SITE MAP
(PROPOSED USE)

18675 St Andrews Dr.
Schedule No:7112305003
Legal Description
LOT 131 Woodmoor Country Club
ADU Addition
zoning R

Lot Plan

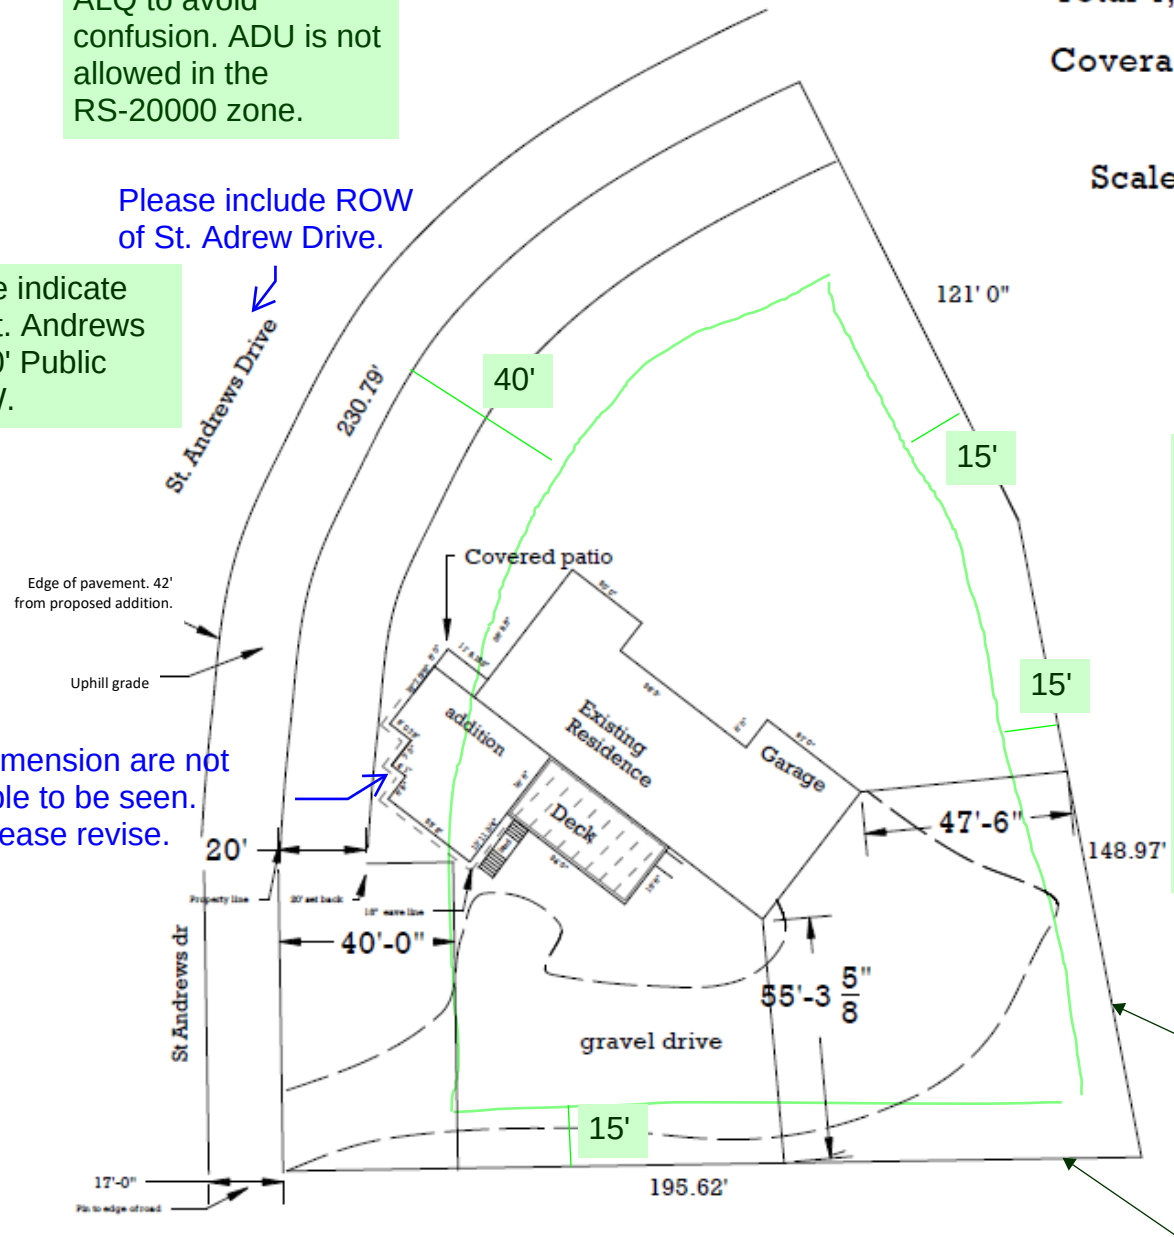
Please include this note discussing the Variance requested:
Front setback of 20 feet where 40 feet is required

Please change to ALQ to avoid confusion. ADU is not allowed in the RS-20000 zone.

Please include ROW of St. Adrew Drive.

Please indicate that St. Andrews is a 60' Public R.O.W.

Dimension are not able to be seen. Please revise.

Show setback requirements for an Accessory Structure in the RS-20000. Staff suggests using a dashed line for clarity purposes (roughly sketched in green) and the setback distances as noted.

Staff suggests making the property boundary a thicker line weight for clarity purposes.
